FIRE FLOW ASSESSMENT REPORT

8520 McArton Road, Ottawa

Revision 3
June, 2023

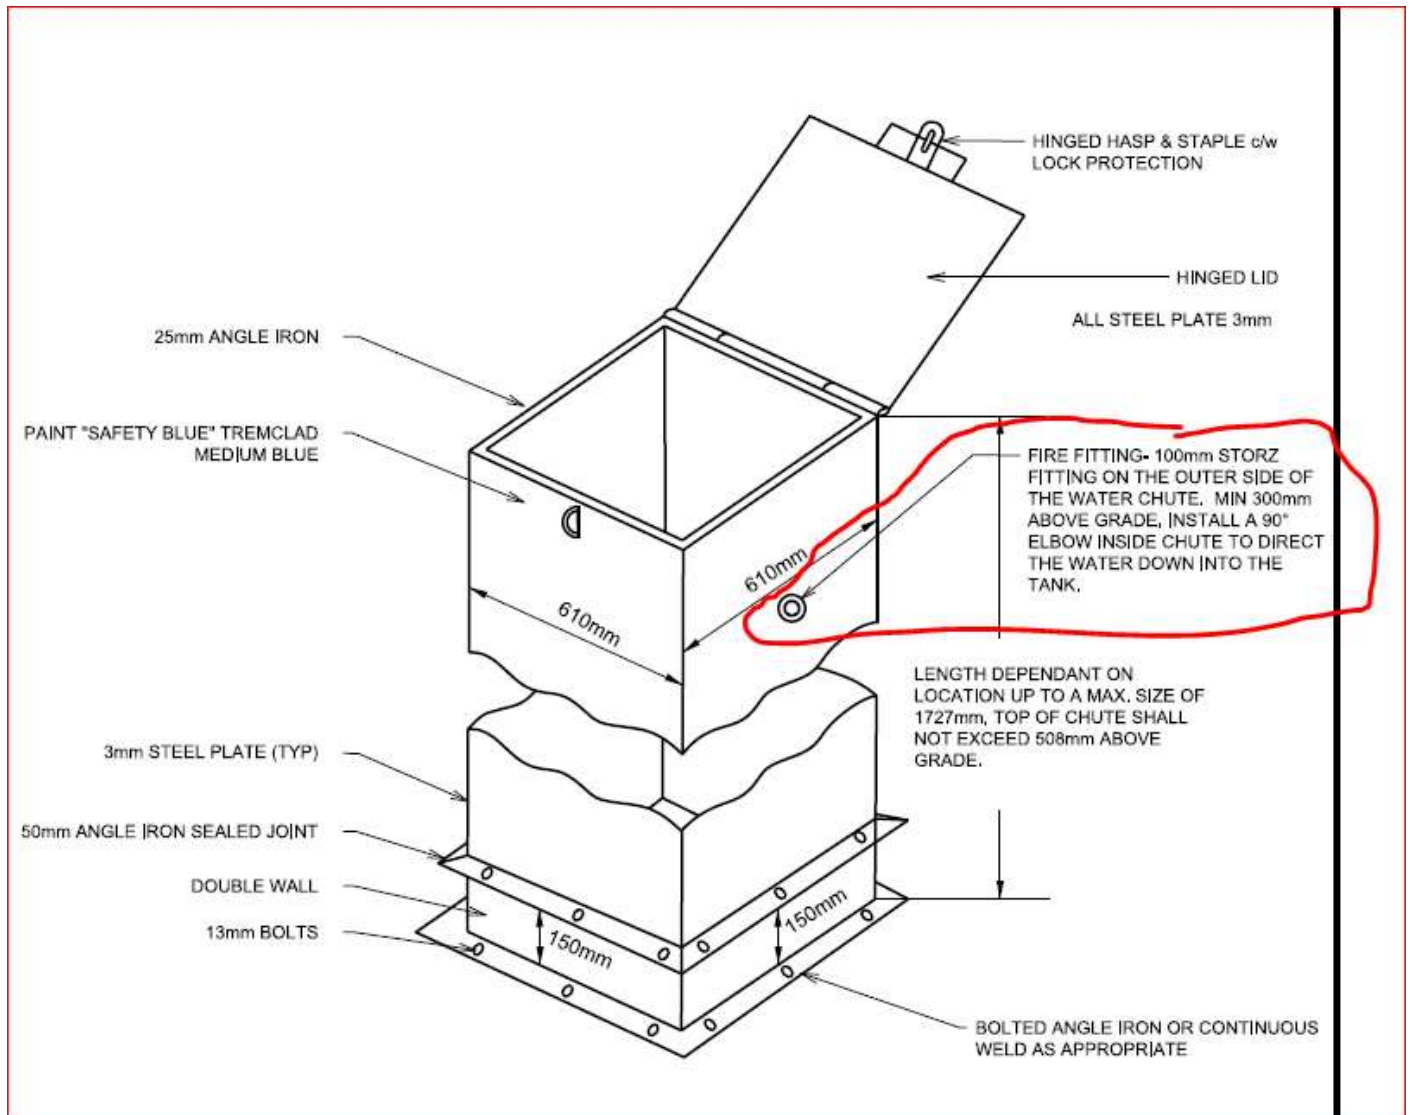
2. Hydrant type. As we have a draft hydrant, it is important to make sure the correct hydrant is used for the application. It must be capable of drafting (negative pressure) and have the correct adapter on it for our trucks (if W51-W54 have not been provided, please let me know). It is also important to note the water table in this area. If there is a chance that the hydrant bottom (where the pipe goes parallel to the tank) will be within the water line (especially in colder months), the fire hydrant must have sealed weep-holes. If the water table is safely below this level, then a normal operating hydrant is fine. The purpose is that when the hydrant is Closed (prevents water from coming from tank), the weep holes open so that the stem (riser) of the hydrant will drain out the bottom and stays dry – in winter, it will not freeze. If the water table is high, then ground water could rise up and potentially freeze and damage the hydrant.

3. Storage tank filling – how will the 50000L tank be filled? The tank is “remote” which is fine for the draft portion of our operations, but we also have a requirement to be able to fill the tank both during firefighting operations and after we are done at a fire at that location. In a standard

setup, we have a blue box on top of the tank directly and they install a 90 degree elbow directed downwards into the tank with a 100mm storz adapter on the outside (see below). We would connect our hose to this adapter and pump water down into the tank to fill. For this setup, the tank is remote from the draft hydrant. They could provide a fill pipe with adapter at that location sort of adjacent to it and run more pipe back to the tanks, but this could lead to a similar freezing issue with the water level rising within the pipe to the same level as the tank itself. They could also put a pipe with the adapter above the tanks provided we were able to get to it. We have lots of hose to run water to the tanks, we just need the ability to get to those tanks (on foot is fine).

Please note that the two fire fighting comments must be addressed in both the Fire Flow Assessment Report and the Site Servicing Plan, as the Servicing Plan must show the fire hydrant type and location along with any other pipes associated with filling the fire storage tank.

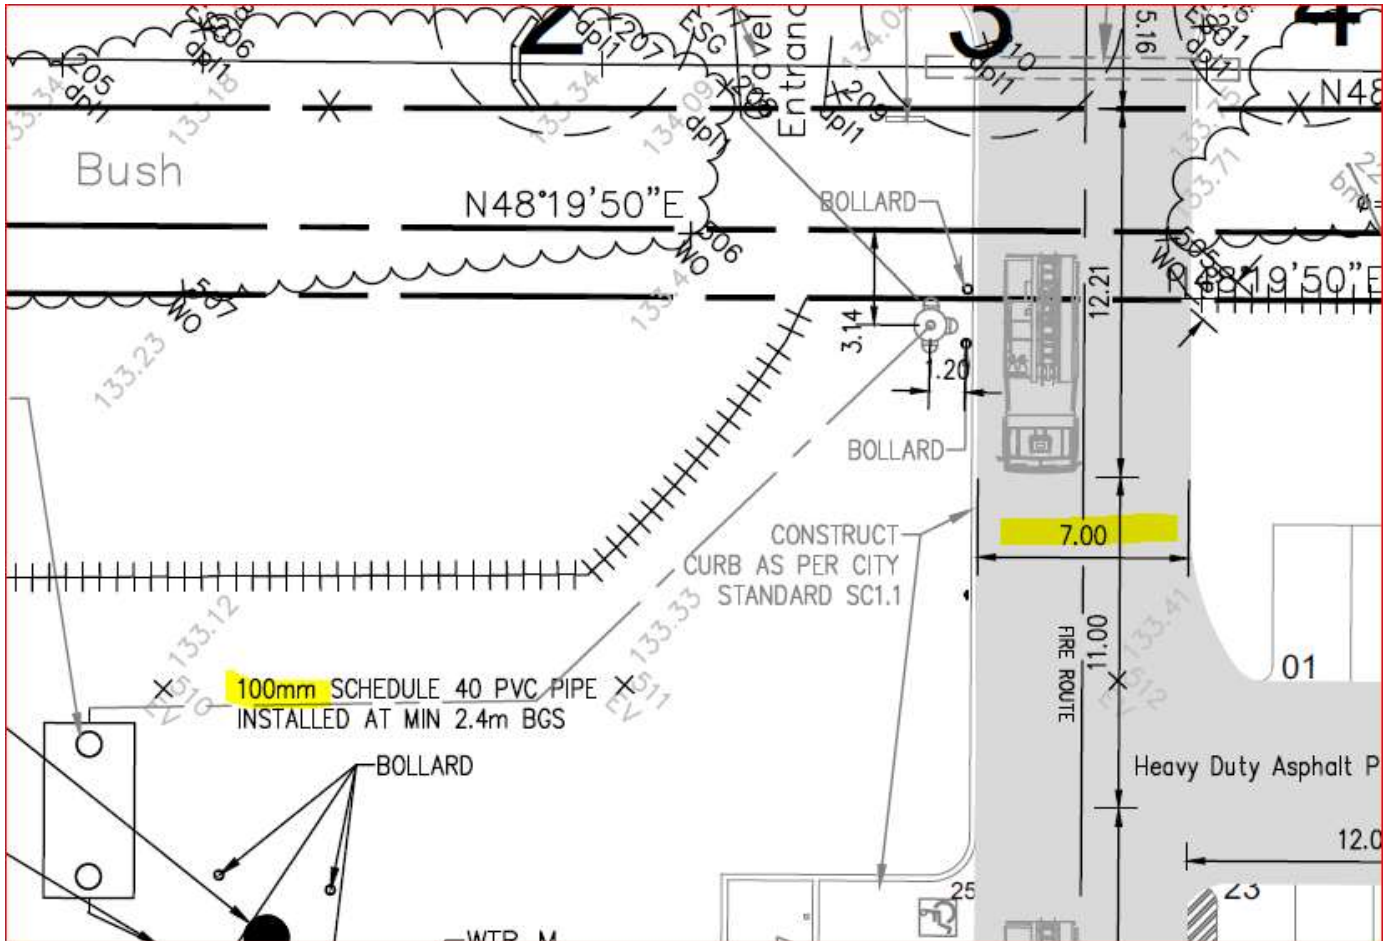
Also, the pipe connecting the storage tank to the hydrant should be a minimum 150mm (6").

I should also mention that if you are using a regular fire hydrant at the entrance, you should be careful to get the correct hydrant. If the water table is too high, you should get a hydrant with the weep holes sealed – this prevents water from coming up from outside and into the vertical pipe and freezing/damaging it in the winter. If the water

table is low enough, a regular hydrant should probably be okay but you should confirm with someone familiar with this type of installation. I don't believe a regular straight pipe with adapter would work as there would be water inside the pipe and subject to freezing.

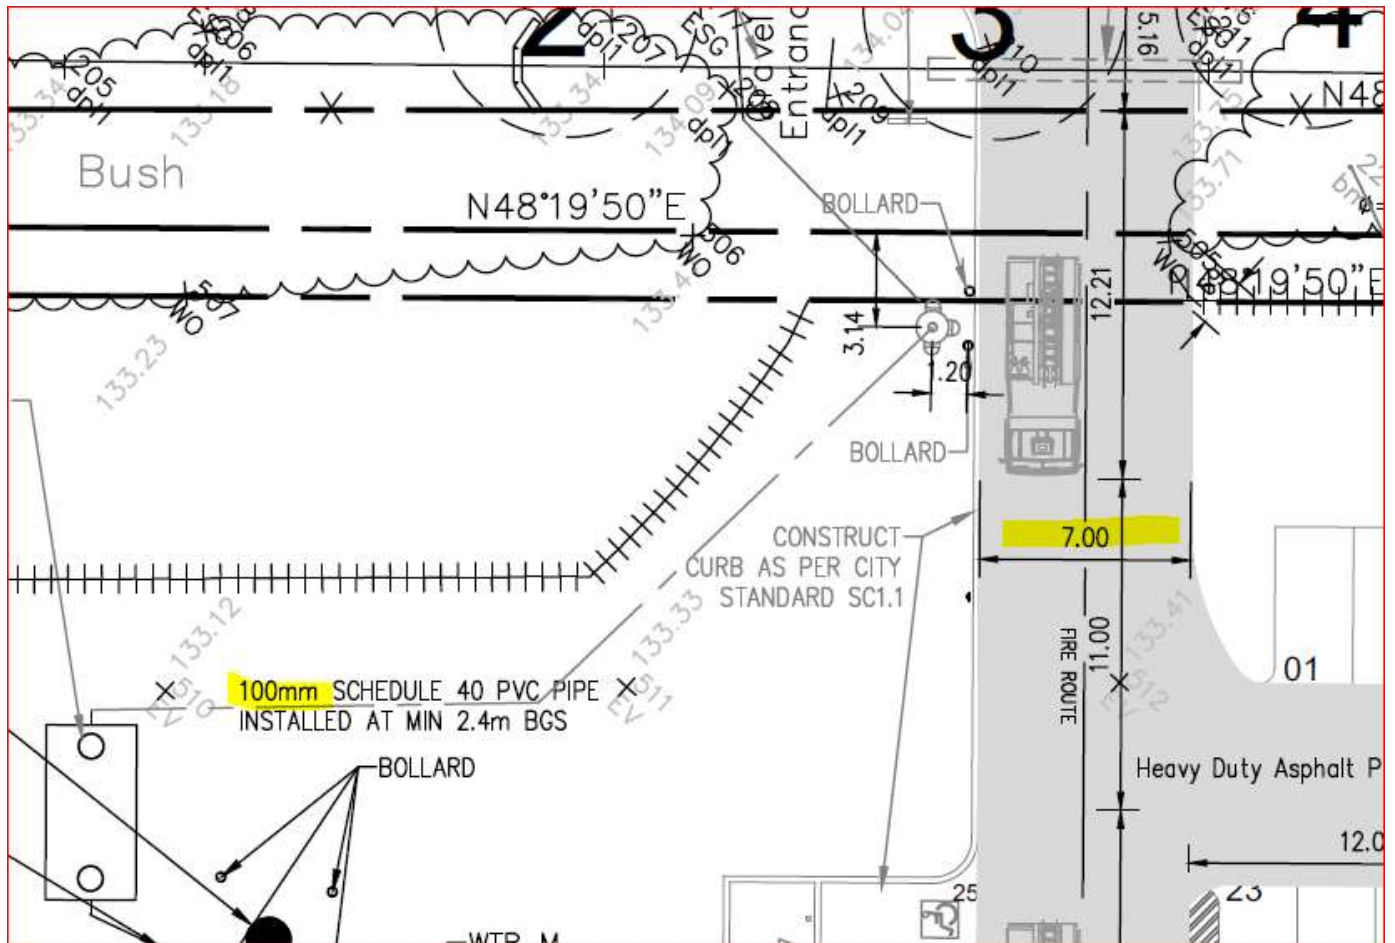
Hello – I am still okay with the 10000 gallon calculation. Please be advised that the new standard in the city is to either build to what the FUS calculates, or to have a proper analysis done by an outside qualified agency explaining why a reduced volume is acceptable – as this application has been progressing for such a long time, I'm of the opinion we can continue as originally proposed, but ultimately this will be up to building code services.

Two further points I see in the drawings:

I should also mention that if you are using a regular fire hydrant at the entrance, you should be careful to get the correct hydrant. If the water table is too high, you should get a hydrant with the weep holes sealed – this prevents water from coming up from outside and into the vertical pipe and freezing/damaging it in the winter. If the water table is low enough, a regular hydrant should probably be okay but you should confirm with someone familiar with this type of installation. I don't believe a regular straight pipe with adapter would work as there would be water inside the pipe and subject to freezing.

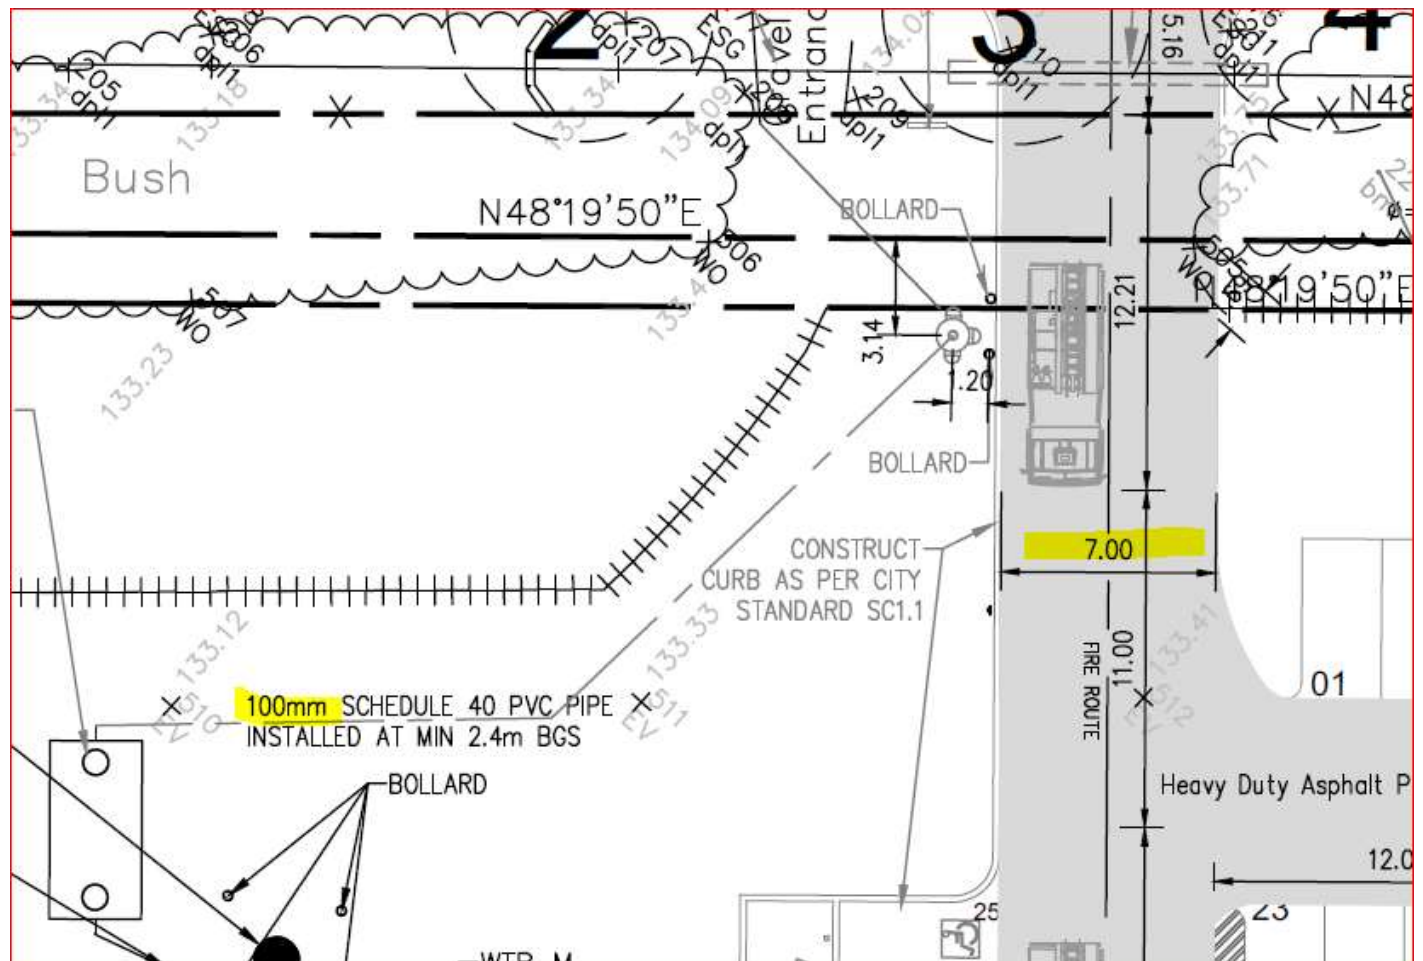
Hello – I am still okay with the 10000 gallon calculation. Please be advised that the new standard in the city is to either build to what the FUS calculates, or to have a proper analysis done by an outside qualified agency explaining why a reduced volume is acceptable – as this application has been progressing for such a long time, I'm of the opinion we can continue as originally proposed, but ultimately this will be up to building code services.

Two further points I see in the drawings:

I should also mention that if you are using a regular fire hydrant at the entrance, you should be careful to get the correct hydrant. If the water table is too high, you should get a hydrant with the weep holes sealed – this prevents water from coming up from outside and into the vertical pipe and freezing/damaging it in the winter. If the water table is low enough, a regular hydrant should probably be okay but you should confirm with someone familiar with this type of installation. I don't believe a regular straight pipe with adapter would work as there would be water inside the pipe and subject to freezing.
